Rezoning Transportation Analysis

Petition Number: 2021-127

Date	Description
09-23-2021	First Review (KP)

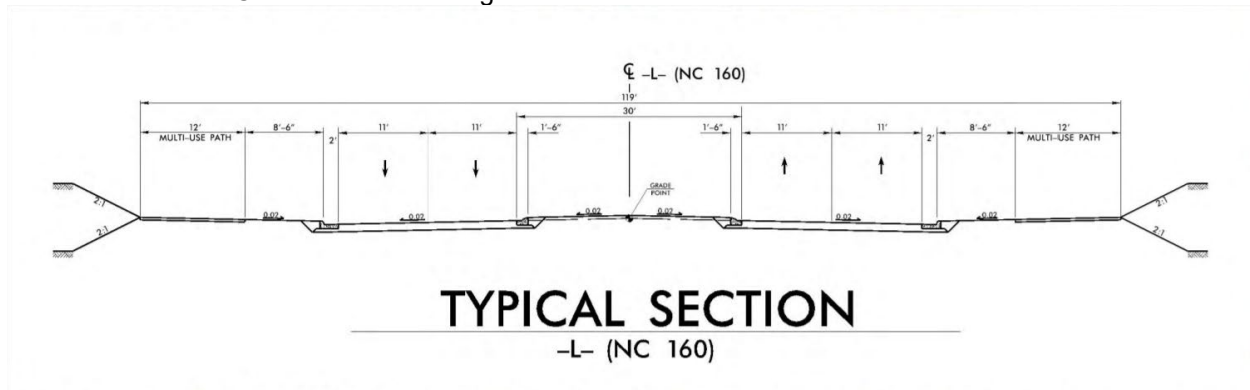
1. Curb line:

- a. **Steele Creek Road:** Curb and gutter is not required with this petition; however, the future location of curb and gutter will be located relative to the typical section associated with U-5766, Steele Creek Road Widening.

Label and dimension the future back-of-curb from the existing road centerline.

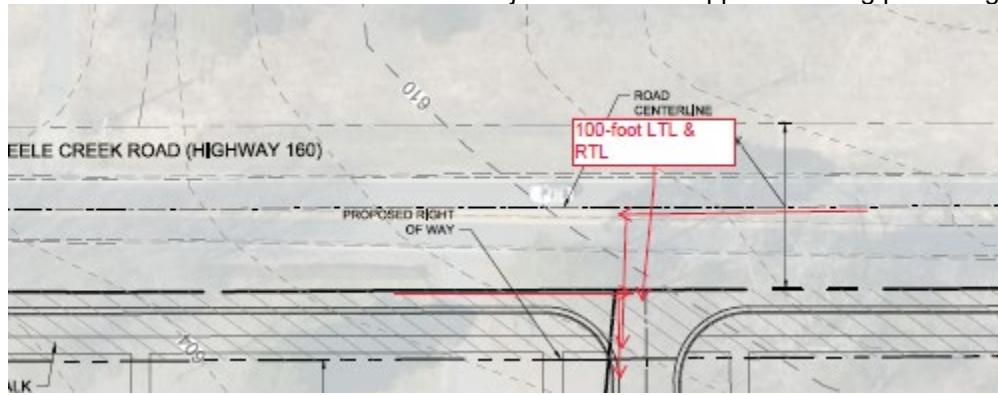
3. In accordance with the typical section associated with U-5766, please refer to outstanding issue 1.a, revise site plan and conditional note(s) to commit to dedicate 60-feet of right-of-way from the existing road centerline. The site plan shall label and dimension the right-of-way from the road centerline.
4. In accordance with the typical section associated with U-5766, please refer to outstanding issue 1.a, revise site plan and conditional note(s) to commit to construct an 8.5-foot planting strip, and a 12-foot shared-use path. Label and dimension the shared-use path from the existing centerline of Steele Creek Road.

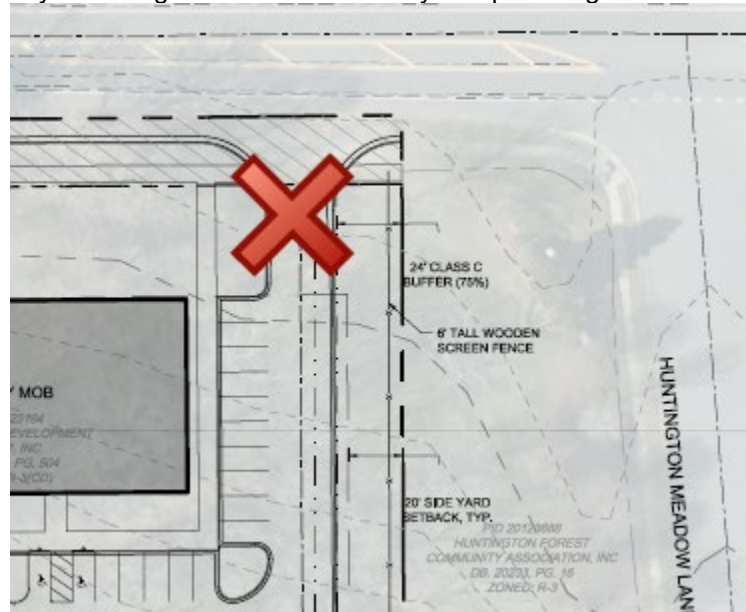
5. Revise the site plan and conditional notes to commit to widen Steele Creek Road and provide a left-turn lane and a right-turn lane into the site. Each turn lane will have 100-feet of storage and an appropriate bay taper length. The widening and turn lanes will be designed and constructed in accordance with NCDOT standards and will be subject to NCDOT approval during permitting.

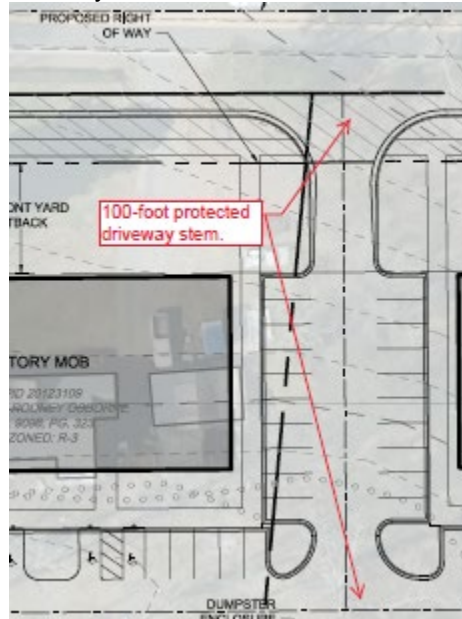
6. Revise the site plan by removing the northern driveway and providing one access point into the site.

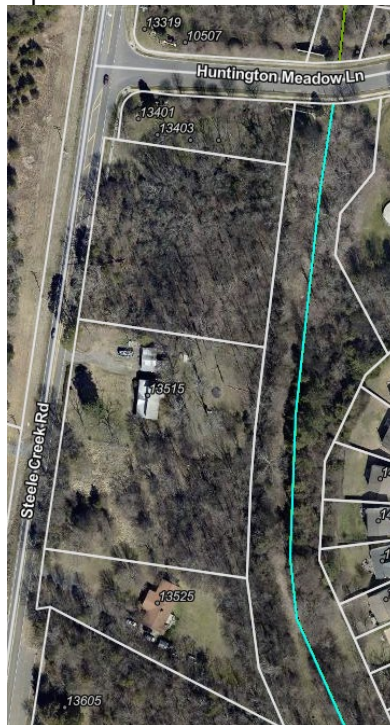
7. Revise the site plan and conditional note(s) by removing the parking along the access drive and providing a 100-foot protected driveway stem.

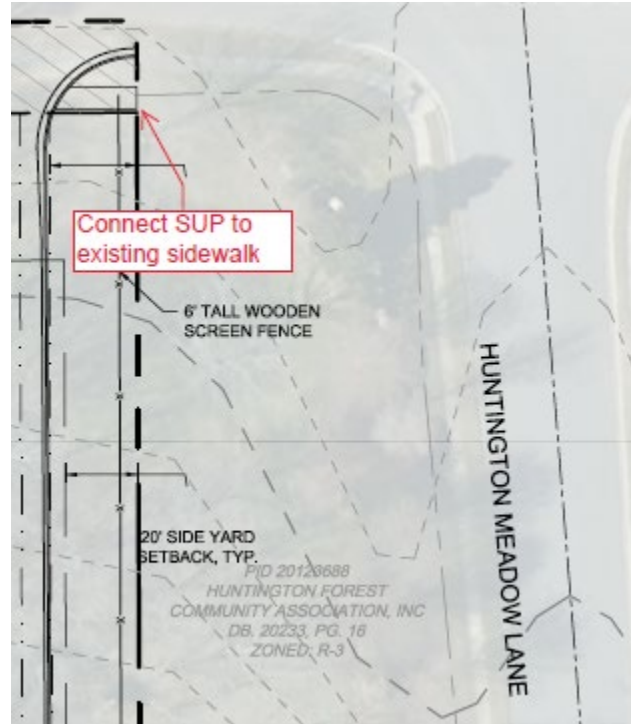
8. Revise the site plan and conditional notes by committing to coordinate with Mecklenburg County Parks and Recreation, during permitting, regarding the alignment of the future Walker Branch Greenway Extension. The goal is to provide transparency between the Greenway Project and projects along the Greenway's anticipated corridor.
